# Access Compliance Report

## Public Rights-of-Way

Intersection ID: 47977	Main Street: AVALY_LN	Cross Street: SPRINGS_MILL_RD	Location: SE
ADA ID: C016E4124C25	Ramp Type: BlendTrans1	Initial Pass/Fail: Fail	Overall Compliance: No
		Severity Score: 8.75

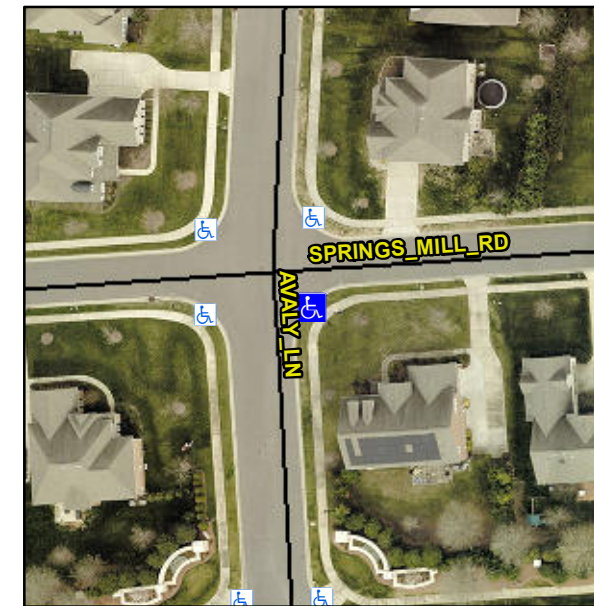
Surveyor Notes:

**CURB GAP 1.5**

PROW/ADA:

**Not Found, R304.5.1**

**Remove & Replace Curb Ramp With Two New Directional Ramps or Equivalent.**
